**Subject** ▶ Change of Joint,Lever,Screw and addition of Hex.Sleeve

**For Models** ▶ 4304T,4305T(JIG SAW)

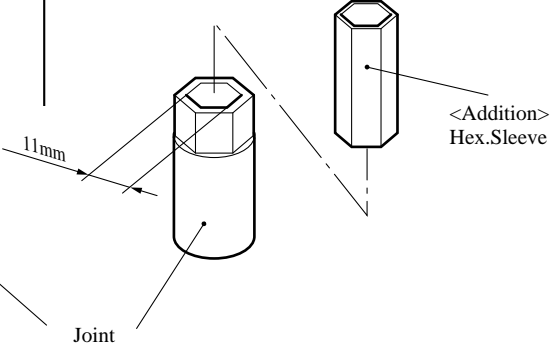
**Description** ▶ Hex.Sleeve has been added to be inserted into Joint to increase strength of Joint.  
Only for Model 4304T,Pan Head Screw M4x8 fixing Lever 51 has been changed to Countersunk Head Screw M4x6. Accordingly the Lever 51 has been changed.
